A201 Blackfriars Station Redevelopment

Permanent Highway Layout

Road Safety Audit

Interim Stage 3

Drawing No: **ALIGNMENT OPTION 2**

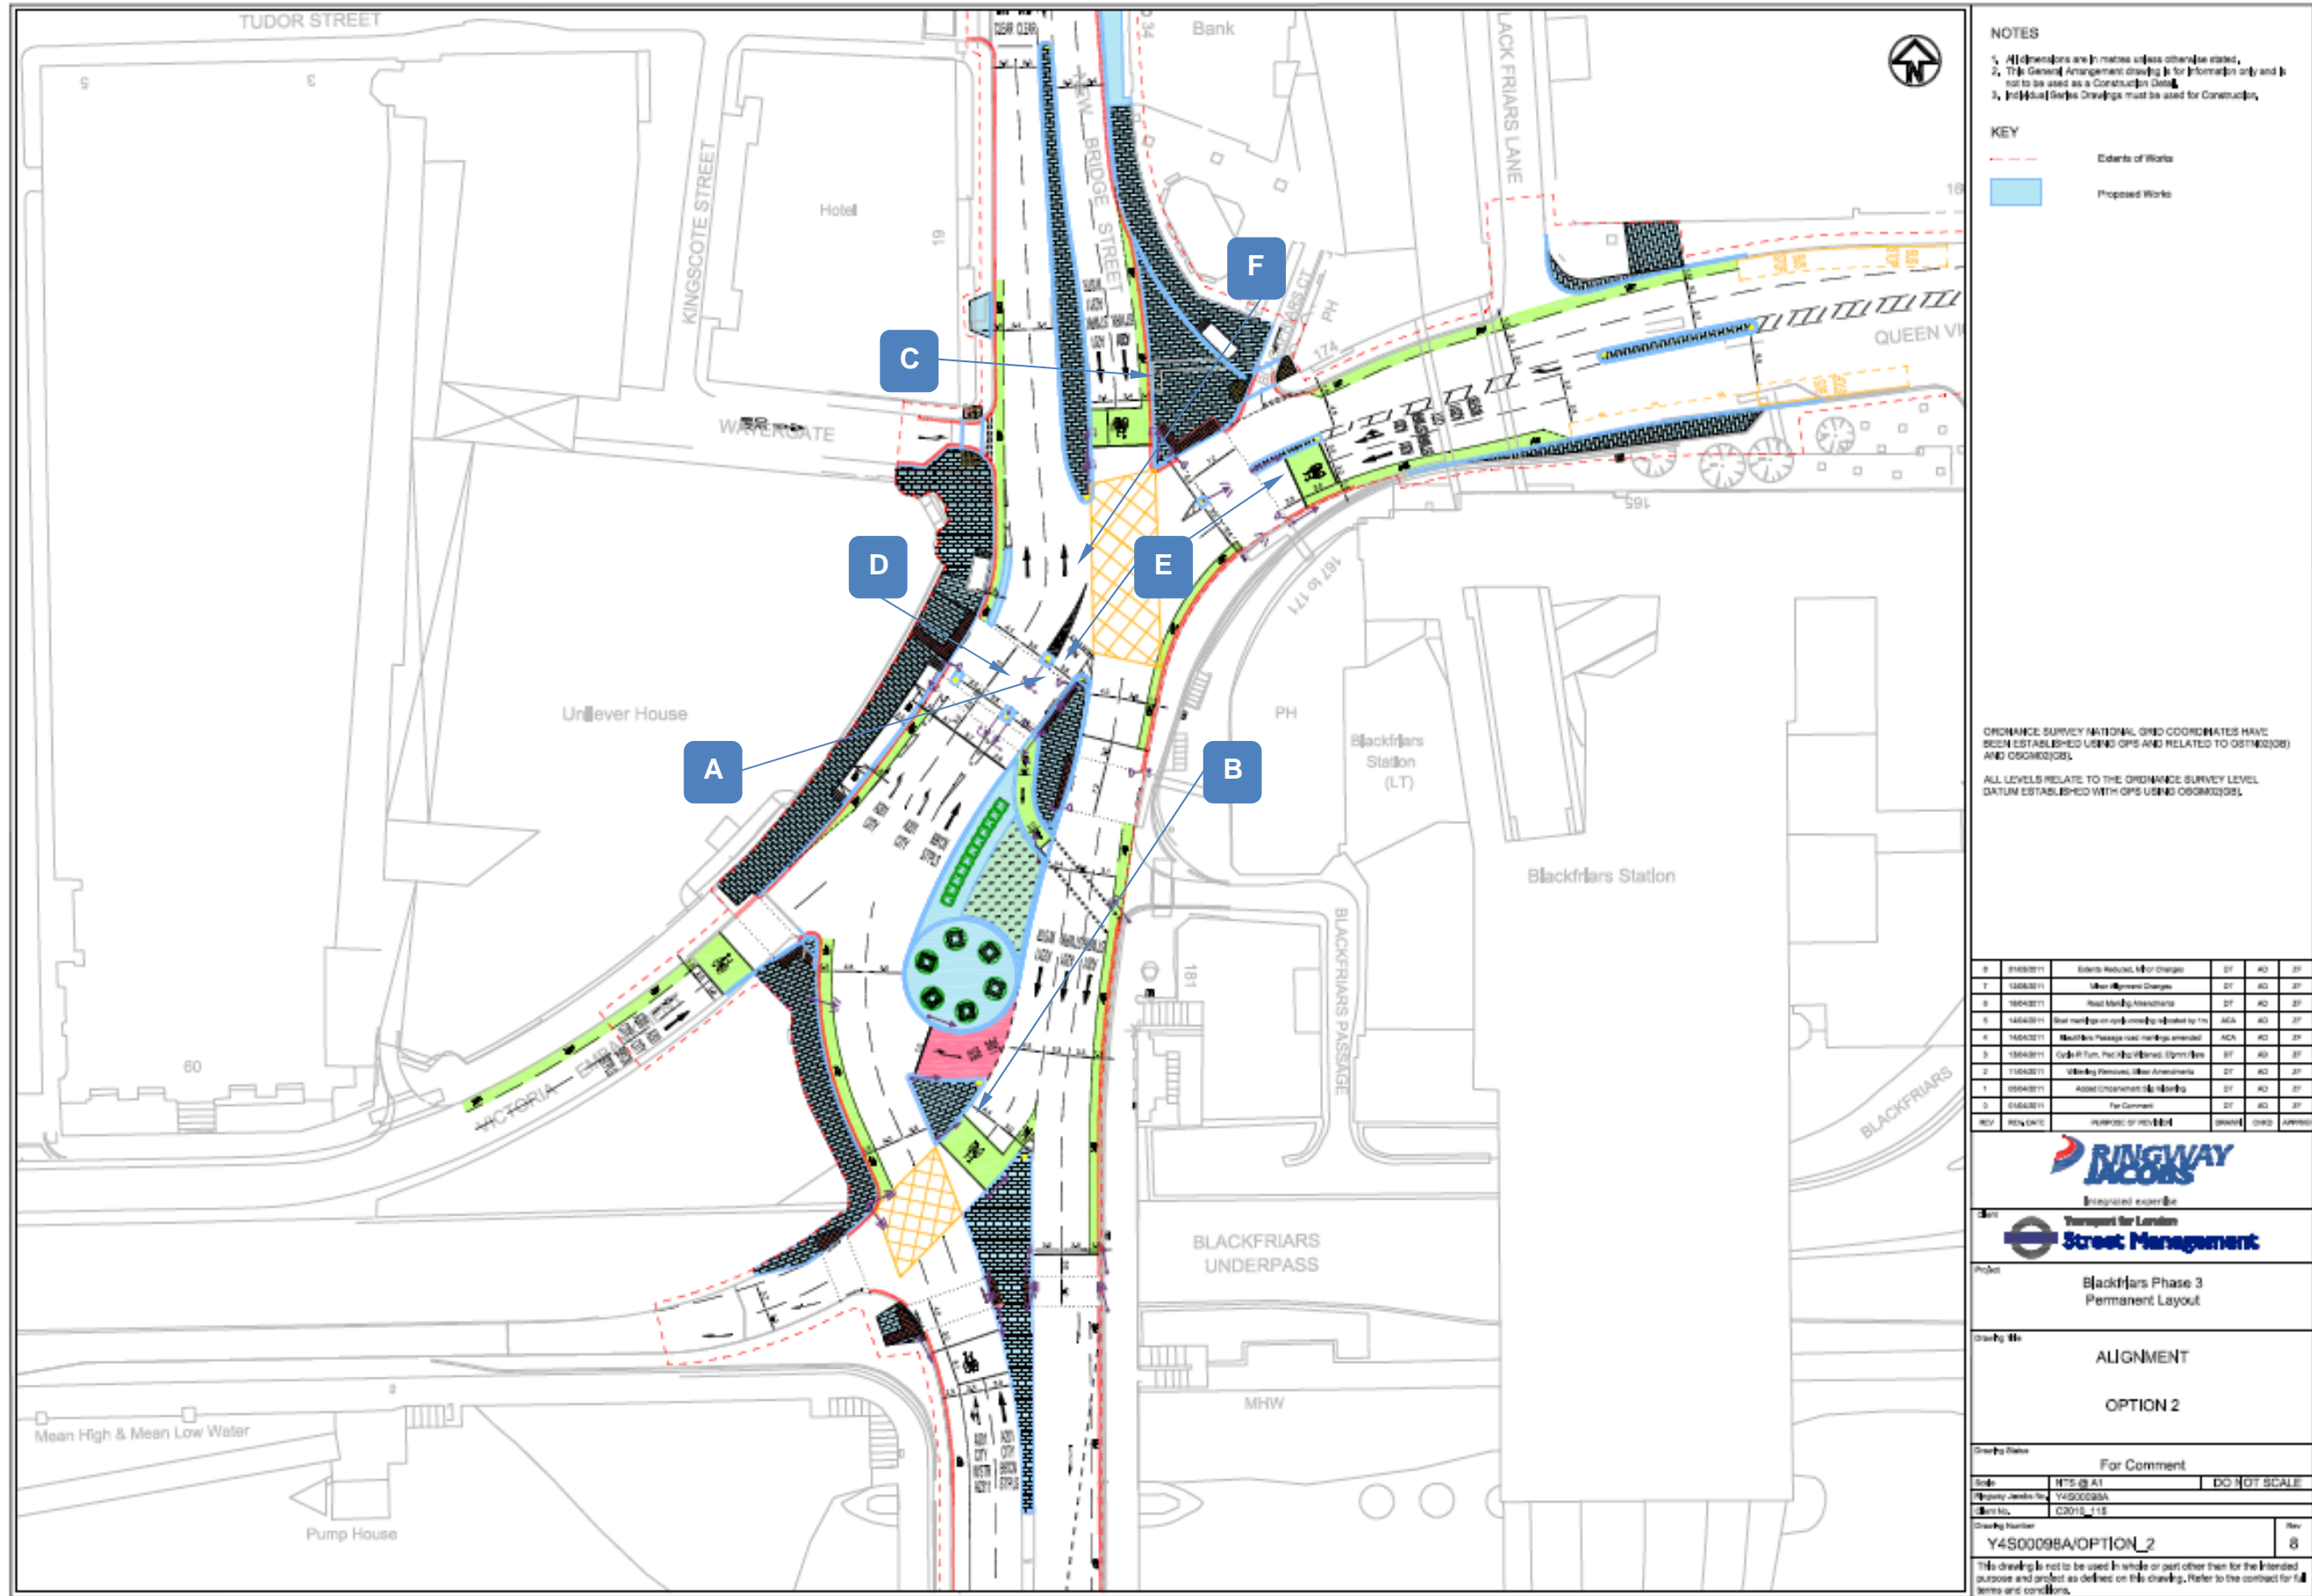
**Location:** A – Approach layouts for cyclists to travel ahead to Queen Victoria Street.

**Summary:** Provision requires cyclists to keep left without a clear route to transition to Queen Victoria Street.

The Audit Team are concerned that the mandatory cycle lanes guide cyclists to the left of the carriageway without any clear route towards Queen Victoria Street. This results in users performing various manoeuvres including crossing three lanes of traffic within a very short section in which other traffic is often changing lanes, increasing the risk of side-swipe type collisions between cyclists and other traffic. Cyclists performing this manoeuvre also ignored the stop lines and crossing facilities in order to 'beat traffic'.

The potential for conflict between cyclists and other traffic is perceived to be significant due to the various manoeuvres that general traffic perform at this location and the short length in which cyclists cross these three busy lanes.

**Location:** B – Approach layouts for cyclists to right turn to Victoria Embankment.

**Summary:** Provision requires cyclists to keep left without a clear route to enable the right turn.

Similarly to the above issue (although not witnessed as a significant movement during the site visit) The Audit Team are concerned that the mandatory cycle lanes guide cyclists to the left of the carriageway without any clear route towards Victoria Embankment. The potential for conflict between cyclists and other traffic is increased due to the various manoeuvres that general traffic perform at this location and the short length in which cyclists cross up to three busy lanes.

**Location:** C – New Bridge Street between Queen Victoria Street and Watergate.

**Summary:** Pedestrian desire line not catered for with controlled crossing facilities.

The Audit Team are concerned that a high number of pedestrians were witnessed crossing at this location without the assistance / protection of a crossing facility. The lack of pedestrian crossing facility at what appears to be a significant desire line increases the risk of conflict as users cross between traffic with an increased risk of being obscured.

**Location:** D – Western crossing point between Victoria Embankment and Queen Victoria Street

**Summary:** Pedestrians may not anticipate flowing traffic in lanes 1 & 2 whilst lane 3 is stationary.

The Audit Team are concerned that pedestrians start to cross as they notice lane 3 (ahead for Queen Victoria Street) is held. Although a 'green-man' is not shown, users of the crossing facility anticipate that any approaching vehicles in lanes 1 & 2 will also be held and so attempt to cross. This may lead to an increased potential for conflict as users have a false sense of security and do not anticipate the approaching vehicles not stopping.

It was also noted at this location that the louvres applied to the pedestrian aspects of the signals mean that the green man cannot be seen at mid-points of the eastern tactile paving.

**Location:** E – Queen Victoria Street junction with Blackfriars Bridge

**Summary:** Potential for head on type collisions.

The Audit Team are concerned that the alignment between the ahead lane into Queen Victoria Street and lane 2 exiting Queen Victoria Street are aligned in a way that they could be perceived as leading towards one another. During the site visit various users were hesitant at this location and one user inadvertently travelled the wrong side of the traffic island towards approaching traffic. An increased potential for 'head on' type conflicts may occur as a result.

**Location:** F – Blackfriars Bridge approach to Queen Victoria Street

**Summary:** Poor lane discipline may increase potential for conflict

The Audit Team are concerned that various vehicles were witnessed during the site visit entering Queen Victoria Street from lane 2 of Blackfriars Bridge which is meant for users continuing left to New Bridge Street. An increased potential for shunt and / or 'side-swipe' type collisions may occur as vehicles performing this manoeuvre have to stop at an unexpected location and then attempt to merge with vehicles in lane 3 entering Queen Victoria Street.

Provide additional facilities to enable cyclists to access Queen Victoria Street safely.

Provide additional facilities to enable cyclists to access Victoria Embankment safely.

Ensure that provision of pedestrian facilities encourages users to safely cross the carriageway. This may include provision of a controlled crossing facility at this desire line.

It is recommended that additional measures / alterations are undertaken to clarify when it is safe to cross. This may include the re-phasing of the traffic signals.

It is recommended that the layout is clarified to ensure that users do not inadvertently enter the opposing traffic lane. This may include alignment alterations, additional signs and road markings to clarify the intended route.

Provide additional lane allocation guidance / information to users approaching Queen Victoria Street from the south.
